RESPONSES TO NRC REQUEST FOR INFORMATION

MARK 1 TORUS PROGRAM PLANT UNIQUE REPORT

YANKEE ATOMIC ELECTRIC COMPANY

VERMONT YANKEE NUCLEAR STATION

V. Y.
ITEM 6

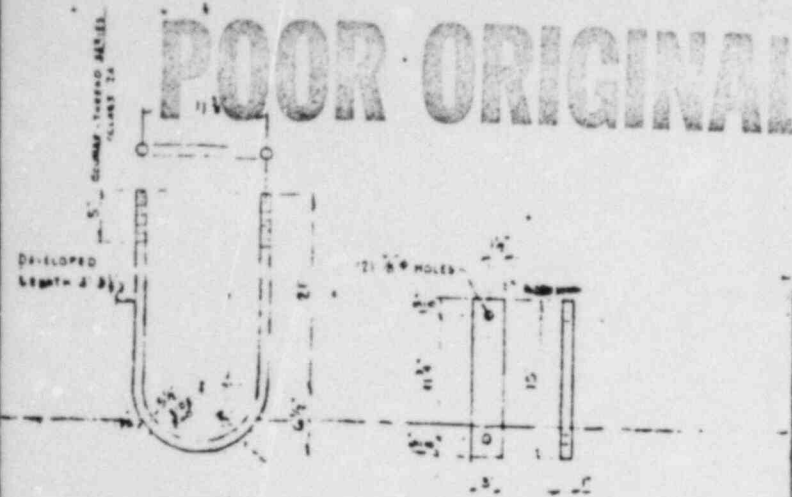
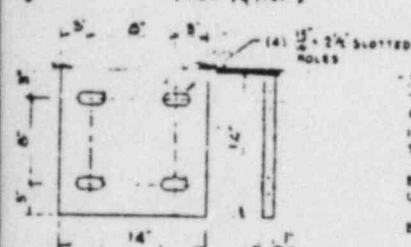
Provide details of the construction of the SRV line as it exists in the Vermont Yankee plant, specifically in the region of the elbow support, if any.

The details of the Safety Relief Valve Discharge Line elbow support and a typical isometric of an SRVDL are included for your review. Note that all four SRVDL's are identical from the vent pipe penetration to the quencher support.
